Fort Saint George, Public Works Consultation of 20th April 1858.

No. 56. Read the following letter from Captain T. THOMPSON, Town Major, Fort Saint George; to Colonel C. A. BROWNE, Secretary to Government, Military Department, dated 12th March 1858, No. 1009.

Letter from Garrison Surgeon J. SANDERSON; to Captain H. ROBERTS, Military Secretary, to the Right Honorable the Governor, dated 6th February 1858.

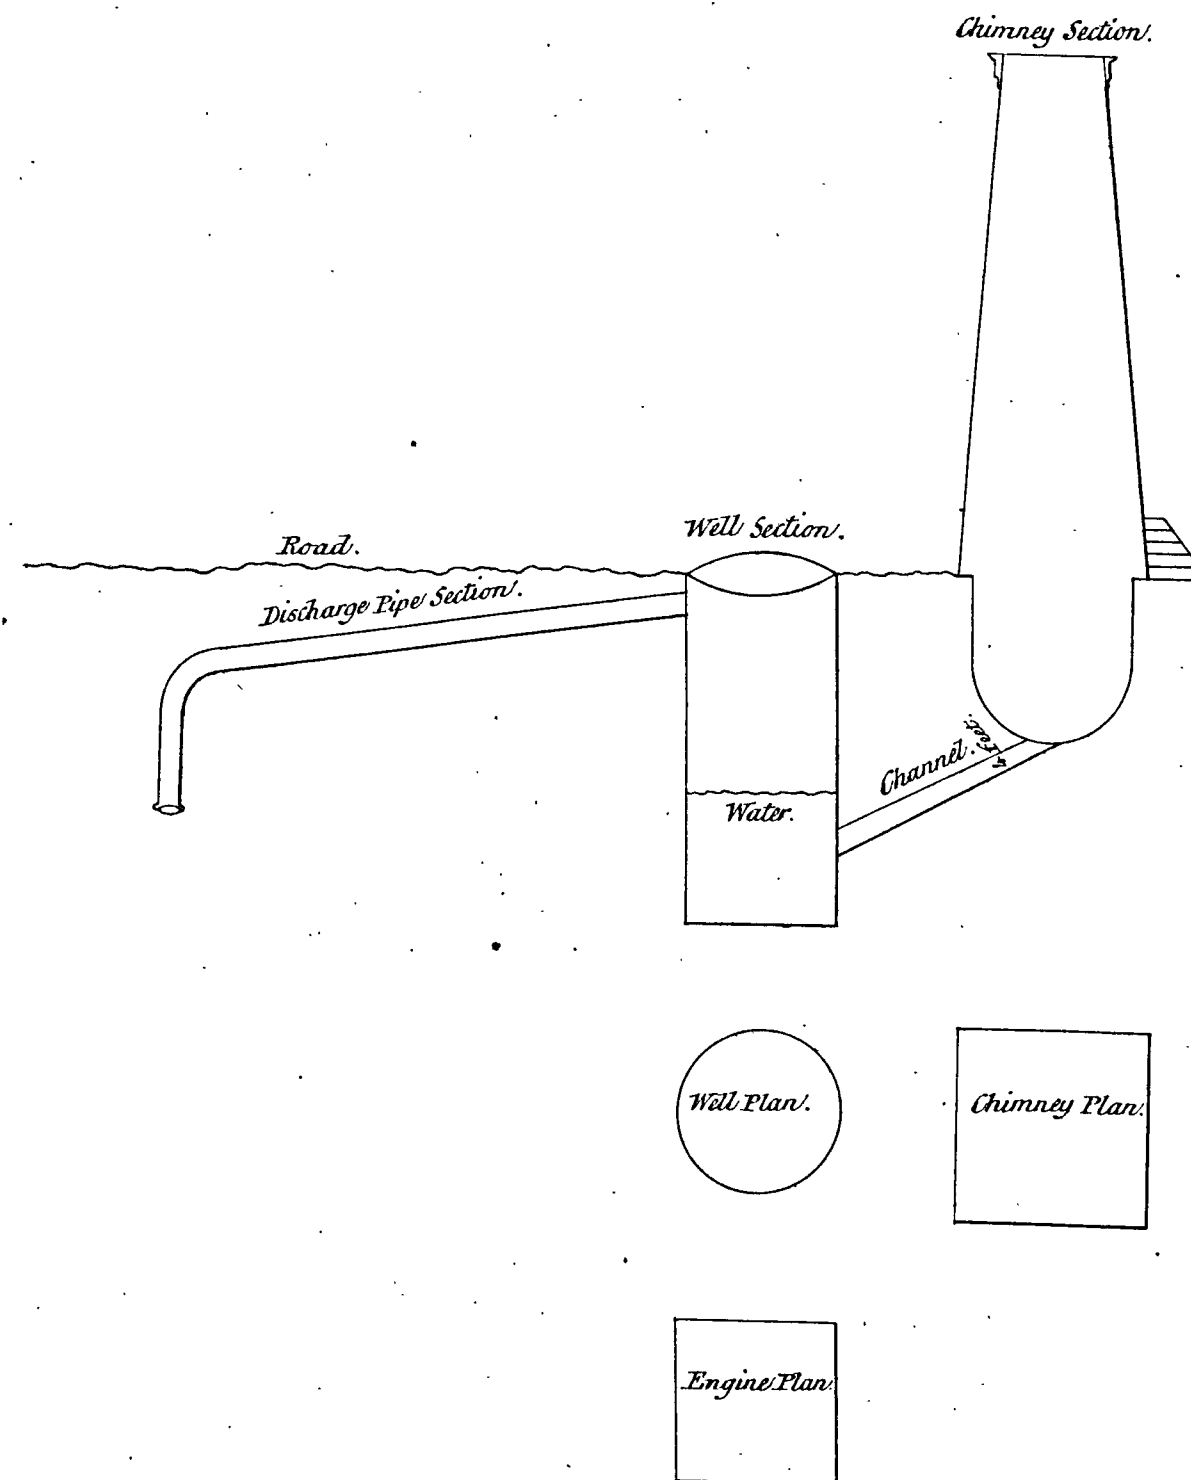
The more maturely I consider your project, the more practicable does it become, as being the only efficient remedy to cure the offensive and unhealthy effluvia arising from the drain situated at the north-east angle of the glaces, and fortunately every means at the present time is on the spot necessary to carry out this project, Engine, Pump, Pipes, and men to work the Engine. Nor are the works requisite for the working of the Engine attended with any Engineering difficulties, being simply the sinking a Well, the carrying the discharge Pipe across the road, and into the Sea, and a shed to cover the Engine, and protect the party working it from the weather, sun and rain.

One of the Engines lately received from England for the Department Public Works would answer admirably to carry out this desirable purpose, the Engine would require a platform five feet square to stand upon, this platform would be placed upon the ground owing to the height of the road above the level of the Sea, the other points to be attended to are viz., a Well at such a distance from the Chimney as not to injure its foundation, the Well to be of sufficient depth for water to rise in it (which is absolutely necessary) to mix with the filth from the drain, to admit of the pumps working, and also to increase the flow of the filth along the discharge Pipe, a channel from the drain with an incline to allow the filth to flow into the Well and mix with the water, the discharge Pipe to be carried across the road at a depth of six inches below its level, then carried along the top of the present Tunnel, extended further out by means of a groin, or on the top of screw piles. Not having the means or the time requisite to take levels to correctly ascertain what inclination could be given to the discharge Pipe, but assuming that a depth of two fathoms is to be obtained about 25 yards from where a boat floats and 35 yards from the mouth of the Well, and that the level of the road is 10 feet above the level of the Sea, this would allow an incline of two inches to each yard, ample.

And as it would not answer to have the mouth of the discharge Pipe open, and perpendicular to the roads, nor submerged, as the flow of water from the waves into the mouth of the discharge pipe, would retard the flow of the filth from the discharge Pipe, and unless some mode is adopted to carry the filth downwards into the Sea, without the wind or atmosphere being able to act upon would only be a partial remedy, as we would still be regaled with puffs of this effluvia, to obviate this entirely a knee joint should be placed at the extreme end of the discharge Pipe, vertical to the action of the waves.

The well to be enclosed at top to prevent effluvia from rising.

Chimney Section

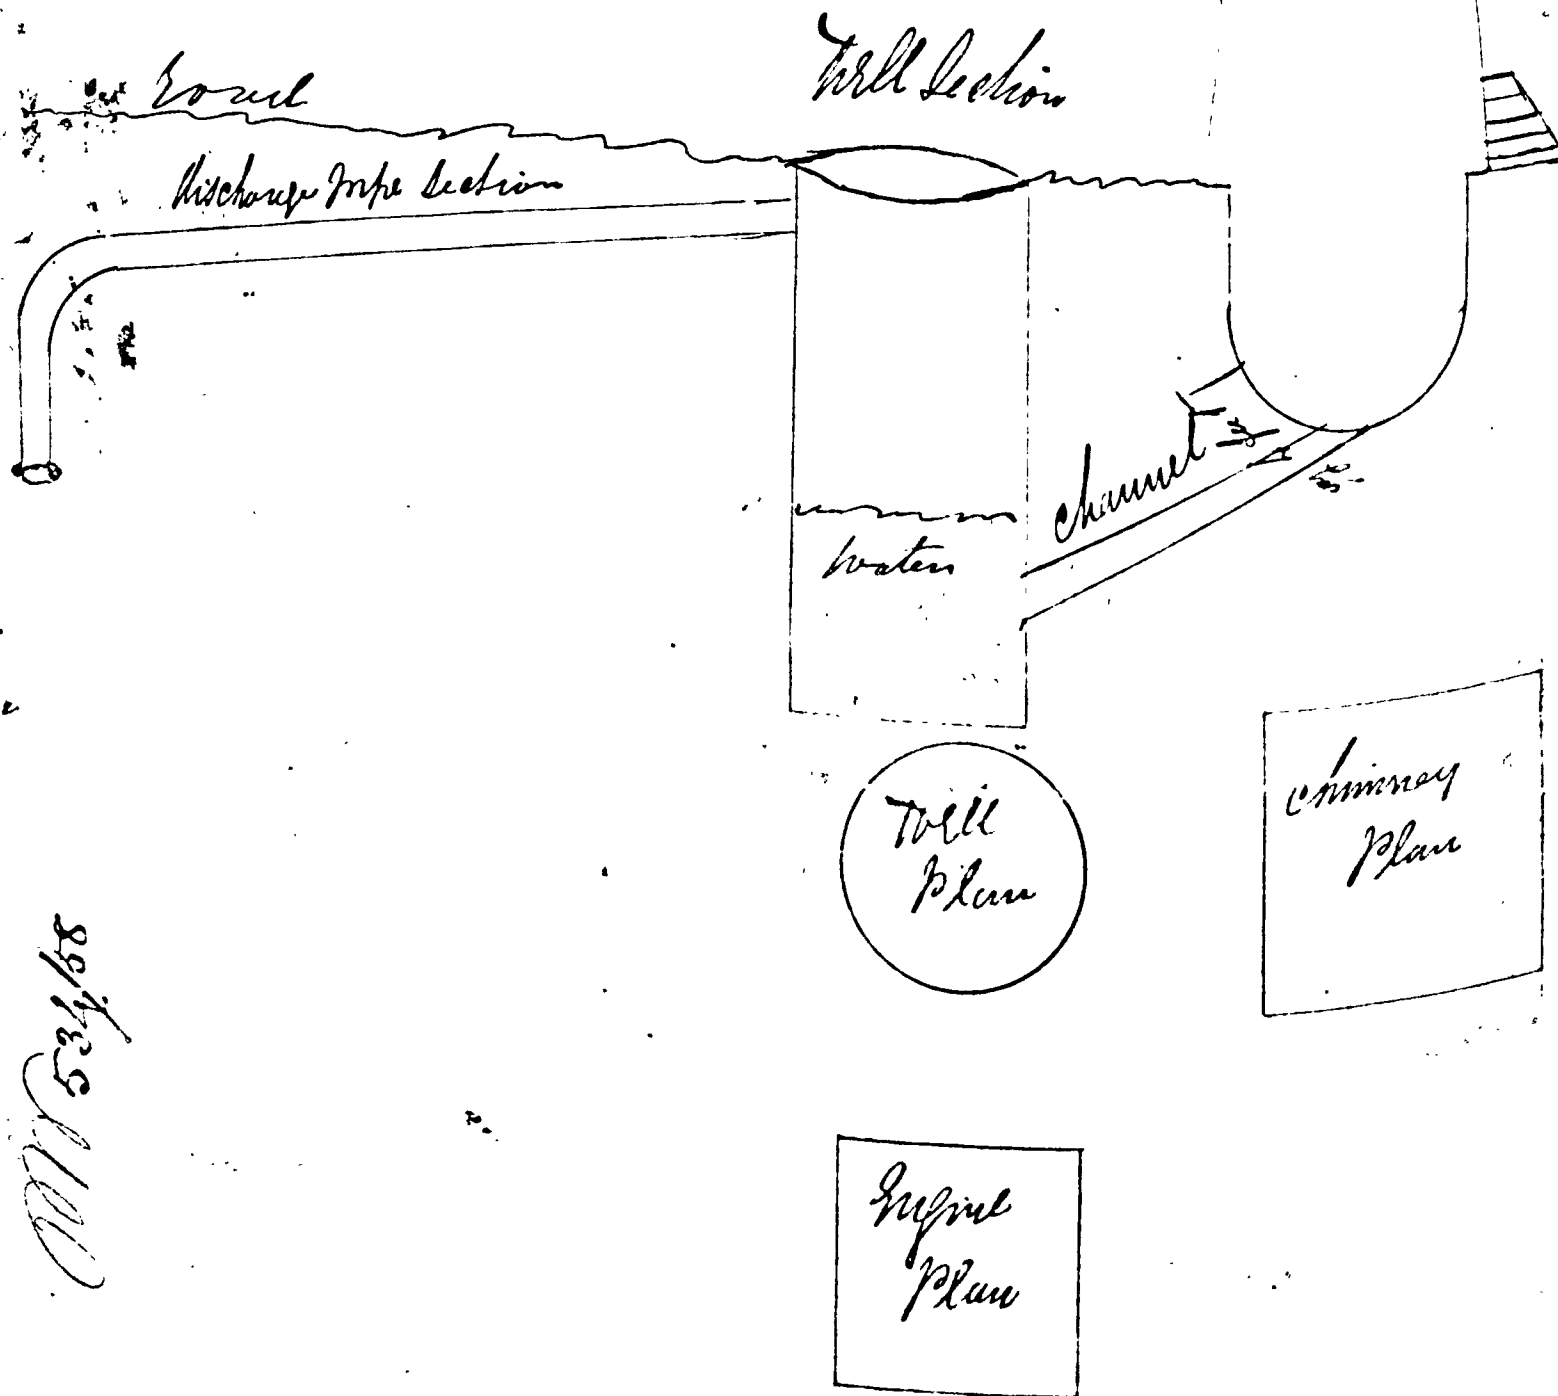
The Well is to be enclosed at top to prevent effluvia from rising.
